**SUBJECT: Transmittal of Westinghouse Responses to US NRC Requests for Additional Information on the AP1000 Application for Design Certification**

# AP1000 DESIGN CERTIFICATION REVIEW

## Response to Request For Additional Information

RAI Number: 220.007 Revision 1

Revised Figure 3.8.3-7  
IRWST Temperature Transient

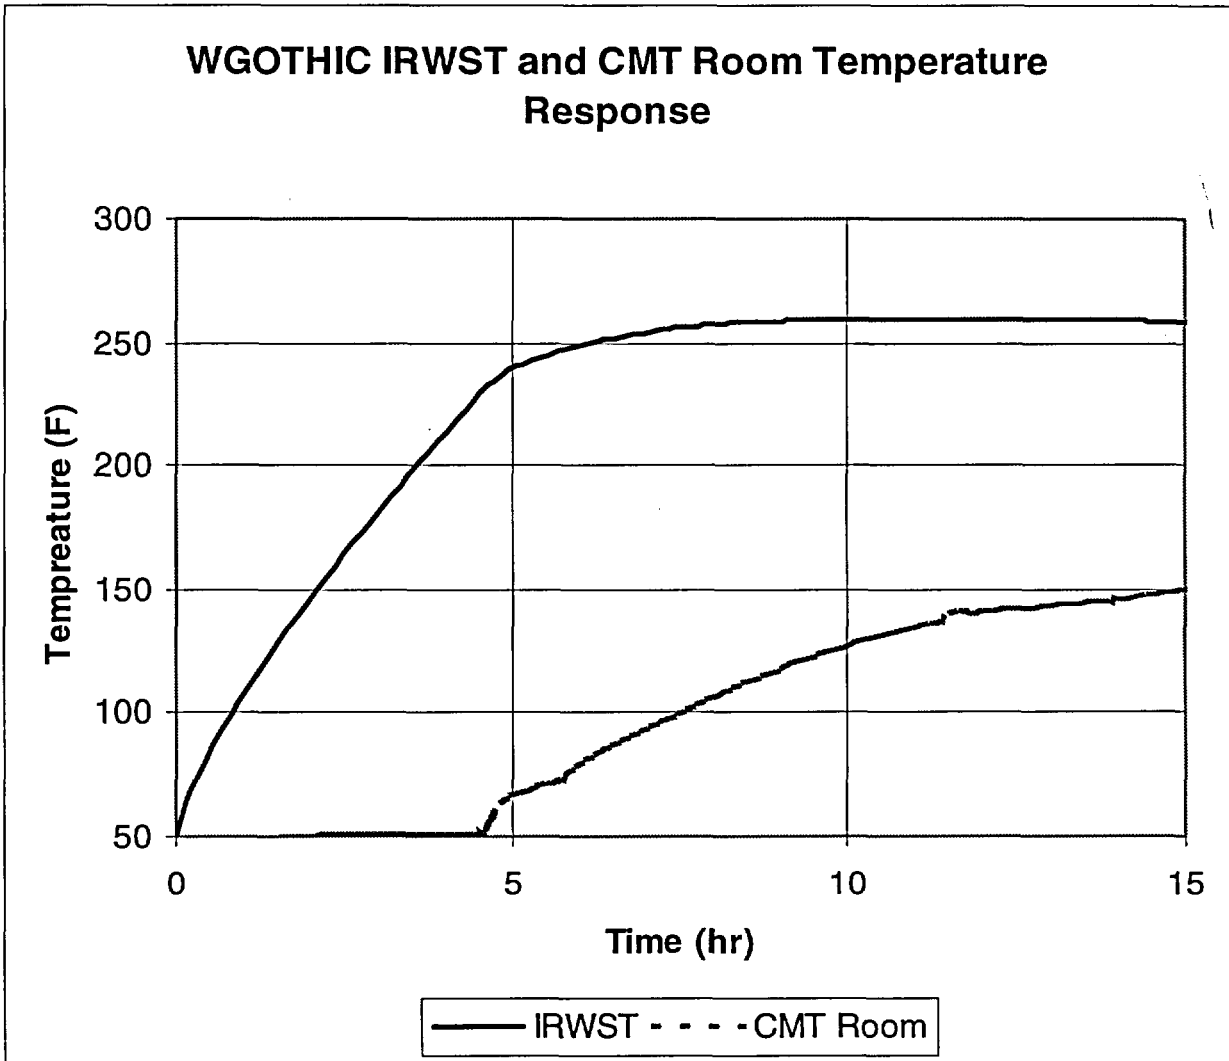
AP1000 DCD Subsection 3.8.3.3.1, "Passive Core Cooling System Loads," describes the pressure and thermal transients associated with operation of the passive core cooling system which are used to evaluate structures inside containment. Some of the water temperature transients have changed from the AP600 design and it is not clear how these have affected the analysis and design of the structural modules. Therefore, please address the following issues:

- A. The transient temperature was revised from 240°F reached in 5.5 hours (AP600) to 250°F reached in 3.5 hours (AP1000). Provide a discussion to explain the change and how this change was considered in the analysis and design of the AP1000 modules?
- B. The extreme transient starting temperature used for the structural design was revised from 50°F (AP600) to 70°F (AP1000). This would seem to be less extreme than the 50°F case in the AP600 design. Provide the basis for this change and explain how this change was considered in the analysis and design of the AP1000 modules?

This RAI response was discussed at the NRC Structural Meetings held at the Westinghouse offices on April 2-5, 2003. At the meeting, it was requested that additional clarification and justification of the analysis assumptions be provided in a revised RAI response.

The thermal transient associated with operation of the passive core cooling system that was provided in the Revision 0 response has been revised. The previous transient was calculated with a simplified bounding model that resulted in overly conservative thermal gradients across the IRWST wall. The calculation has been revised using the Westinghouse WGOTHIC containment model that is used to perform the Chapter 6 design basis containment analysis.

The IRWST temperature transient is shown in the attached revised DCD Figure 3.8.3-7. The temperature transient has been modified based on a more conservative assumption regarding the cooldown time of the reactor coolant system.

The IRWST begins steaming approximately 4 hours after the event is initiated, and reaches a maximum temperature of 260°F in approximately 11 hours. The containment atmosphere heats up once the IRWST steams. This transient will be used to determine the thermal loads on the IRWST walls. Also shown in Figure 3.8.3-7 is the CMT room atmosphere temperature which serves as the boundary condition on the opposite side of the wall. There are no changes in the analysis or design criteria for the structural modules for thermal effects. The critical loading for the concrete filled steel plate modules above the containment internal structure basemat is the thermal gradient across the wall. Close to the containment internal structure basemat the critical loading is the maximum temperature difference between the steel plate and the basemat concrete. The design of the structural modules for the AP1000 IRWST transient will be available for review during the NRC audit of critical sections.

The attached figure replaces DCD Figure 3.8.3-7

Figure 230.022-1  
Free-body Diagram for Containment Internal Structures Overturning Evaluation

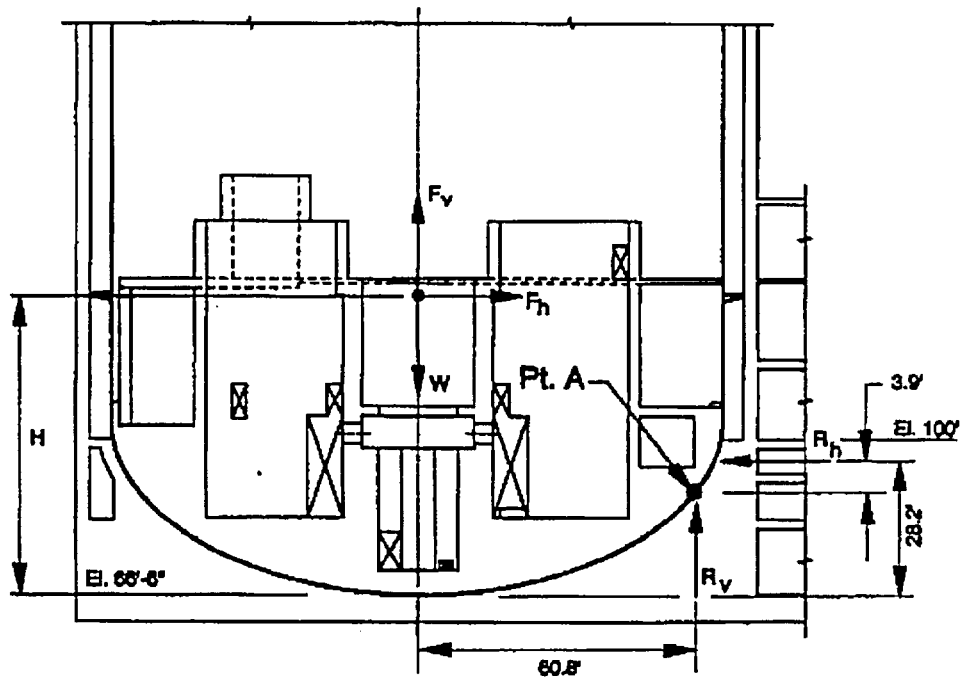
The basemat is represented by a three-dimensional finite element model with the computer program ANSYS (Design Control Document (DCD) Reference 21). The model considers the interaction of the basemat with the overlying structures and with the soil. Provisions are made in the model for two possible uplifts. One is the uplift of the containment internal structures from the lower basemat. The other is the uplift of the basemat from the soil. The staff notes that uplift and slapping back of the containment internal structures on the basemat would affect both the seismic design loads and in-structure response spectra for all SSCs associated with the containment internal structure, and would also affect the seismic response of the steel containment shell. Please clarify how these effects have been addressed in the seismic analyses used for design of the containment and containment internal structures.

The bottom head of the containment vessel rests on the nuclear island basemat. The containment internal structures basemat rest within the bottom head. There are no shear studs or anchors designed to transfer loads tangential to the vessel surface. The interface is designed to transfer load in compression and friction. The configuration is identical to the AP600 and the stability evaluation shown in Figure 230.022-1 follows the AP600 methodology described in the AP600 response to RAI 230.47.

The provisions in the nuclear island basemat model are included for use in the equivalent static analyses to develop design loads for basemat design. The uplift capability assures that the reaction between the two basemats is correctly transferred as compression loads only. The stability evaluation shows a factor of safety against overturning of about 2.5. Since the deadweight has not been overcome no "liftoff or slapping" is expected to occur. However, allowing for a small separation of the containment internal structures from the basemat, there would be no significant effect to the seismic design loads or the in-structure response spectra. A small separation (slapping) might cause small localized changes in seismic response loads similar to those for the lift off observed between the nuclear island basemat and the rock addressed in the response to RAI 230.021. Any change in high frequency response due to "slapping back" would not propagate through the building structures to affect the seismic response. This is because of energy loss, damping, and filtering effects due to gaps and cracking. Therefore, it is not necessary to modify the analysis methods from those that were accepted by the NRC for the AP600 plant.
